PLANNING DIRECTOR'S SPECIAL PERMIT
1231 "I" STREET, SUITE 200, SACRAMENTO, CA 95814

APPLICATION: A. Negative Declaration
B. Planning Director's Special Permit to exceed the 25 percent office use allowed in the M-1 zone by allowing 7,818+ square feet of office in a proposed 15,636+ square foot warehouse building on 1.04+ vacant acres in the Light Industrial (M-1) zone.

LOCATION: 3670 Business Drive (Building C)

APPLC. NO. P90-427

EXHIBIT B

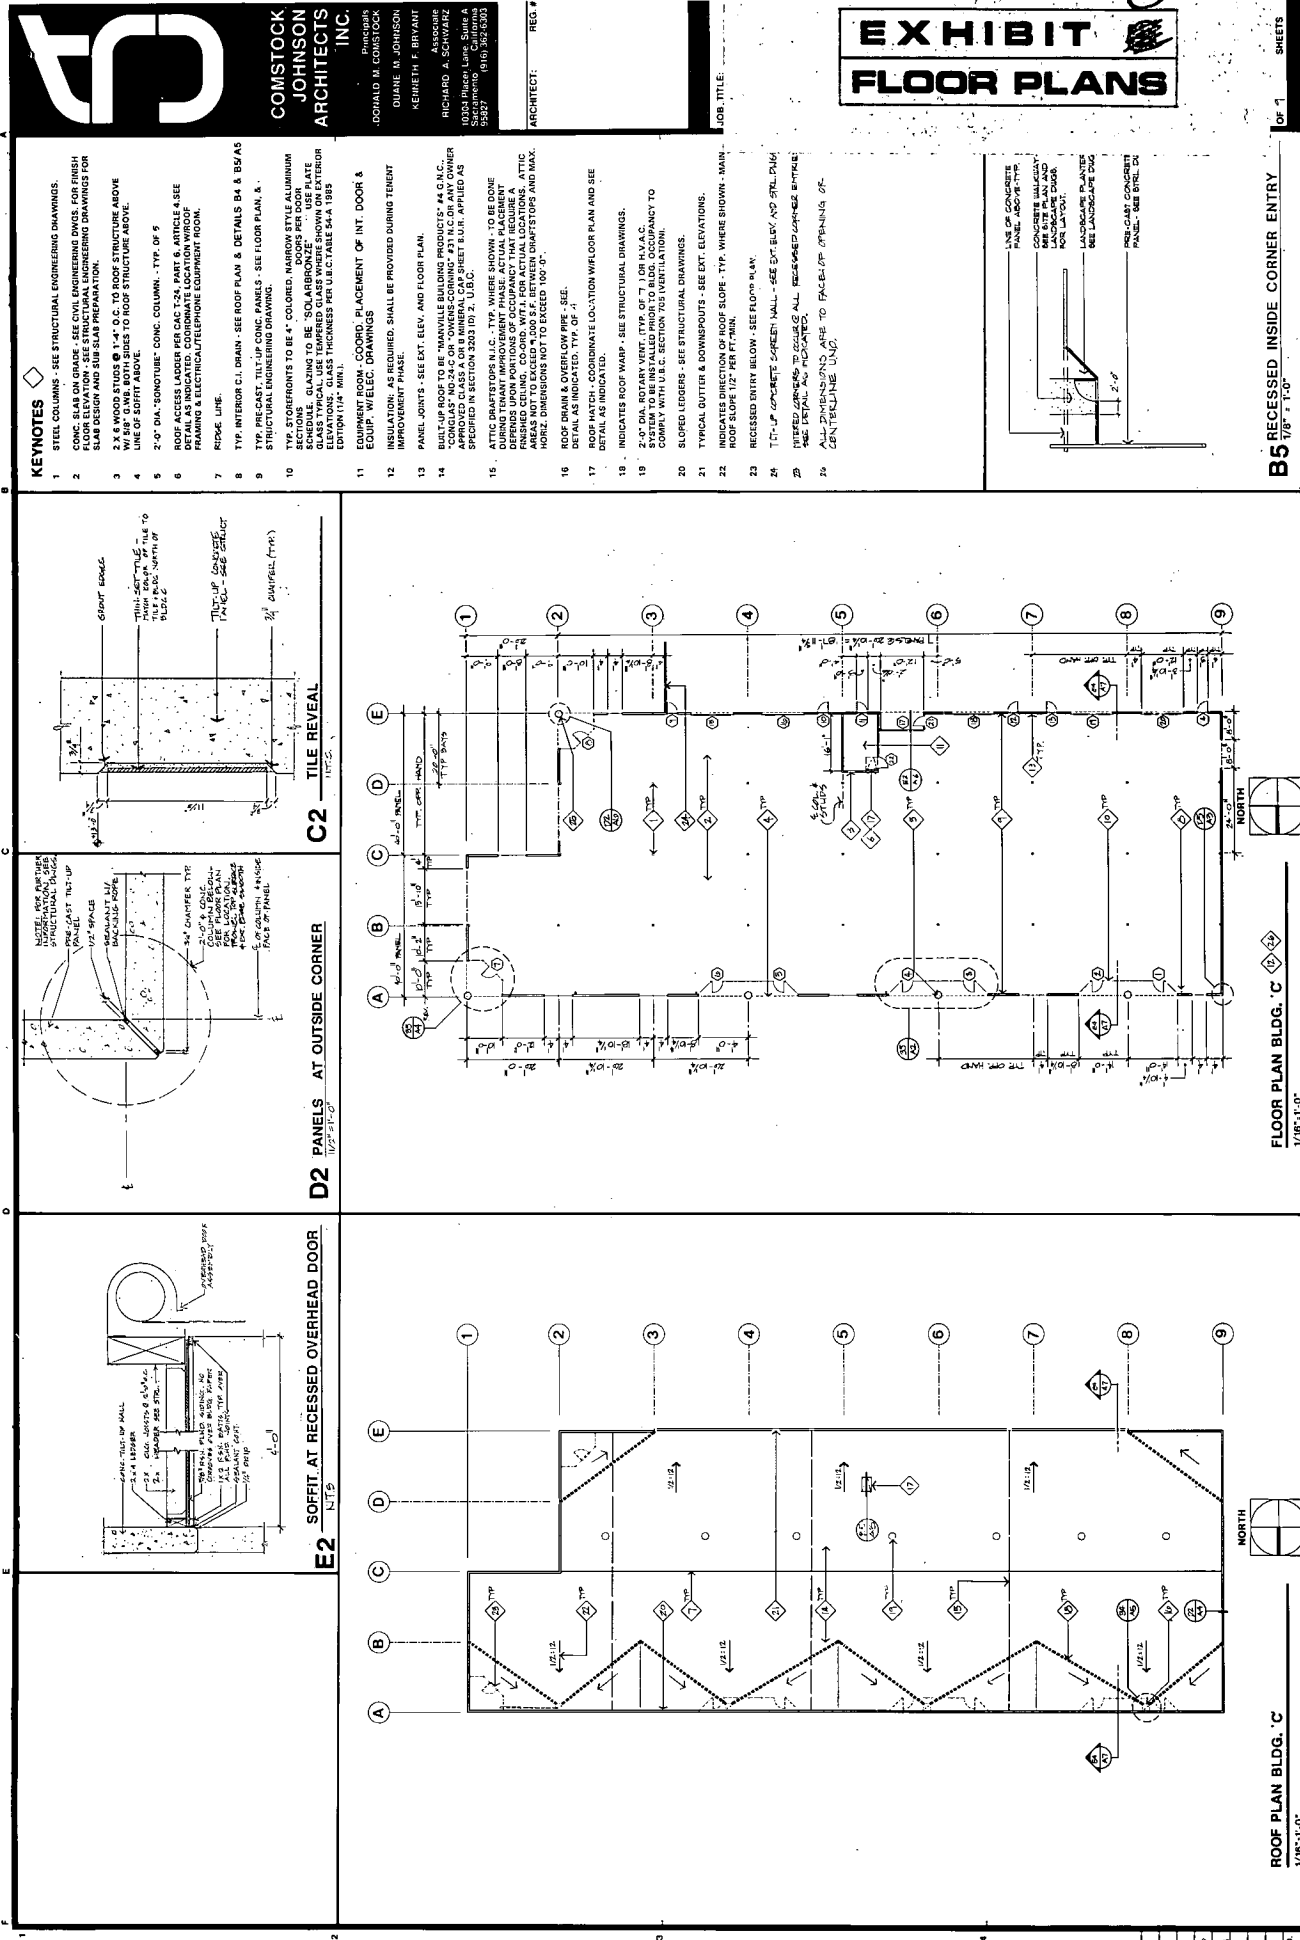
The compact space located at the southeast corner of the building encroaches into the driveway entrance (Exhibit B). Staff recommends this space be eliminated and a planter be located in this area. Staff further recommends five spaces be eliminated at the rear (west) of the site and be replaced with additional planter areas at the sides and middle of this parking section (Exhibit B). By incorporating additional planter space in this area it will eliminate the parking area and prevent cars from parking in the unmarked spaces. It is staff's judgement that converting the compact spaces to standard parking could not be provided unless the building size is reduced or redesigned.

Traffic Engineering - Redesign parking in front of Building C and adjacent to driveway on Business Dr. to the satisfaction of the City Traffic Engineer

3. Five compact spaces shall be eliminated at the rear (west) of the site and additional planter area shall be provided. The redesign of the parking area shall be subject to review and approval of the Planning Director.

4. The compact space located at the southeast corner of the building which encroaches into the driveway entrance shall be eliminated and a planter be located in its place. The redesign of the driveway shall be to the satisfaction of the City Traffic Engineer.

Revised: Additional Planter Area to be provided

**EXHIBIT D
ELEVATIONS**

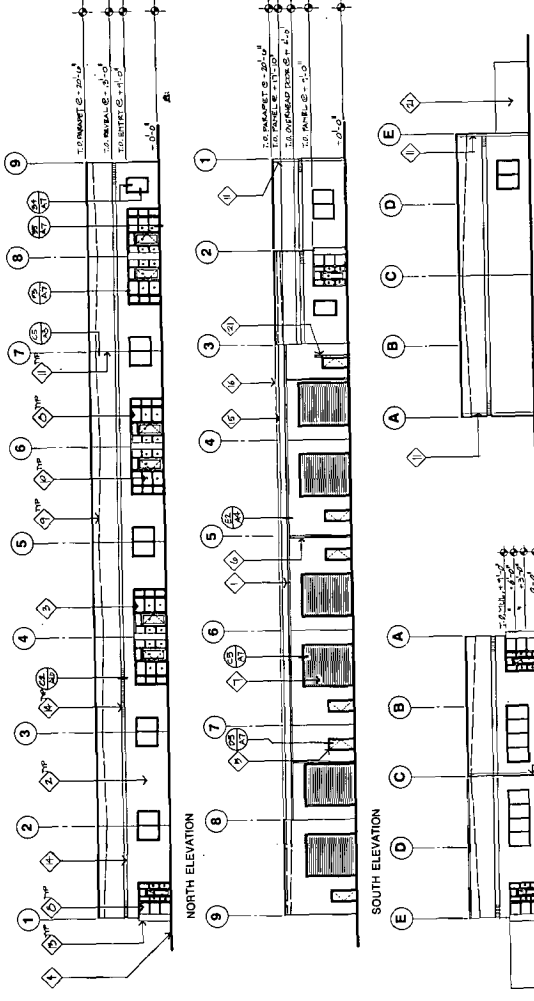
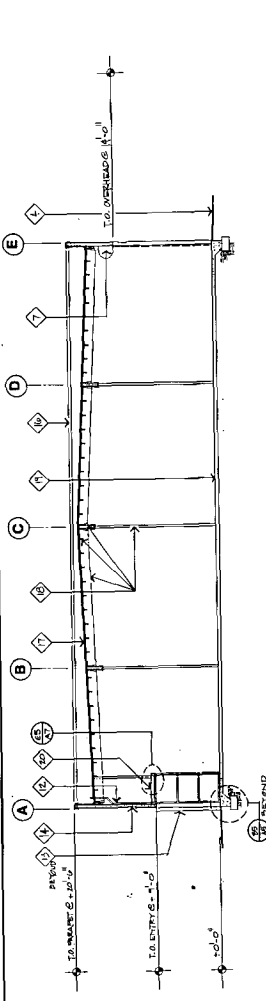
The north and east elevations will consist of store fronts of four inch colored, narrow style aluminum sections with solar bronze glazing. The south elevation will consist of loading doors. The southeast corner of the building will have a recessed storefront facade with a screen wall approximately 28+ feet from the corner to screen the loading area. The west elevation, which faces residential uses will not have any openings except for one window. The building is located 47+ feet from the west property line and is consistent with the conditions of the map. The proposed building will be of pre-cast tilt-up concrete panels with reveal lines and a built-up composition roof. Staff recommends the colors should be compatible with the existing buildings located in the area.
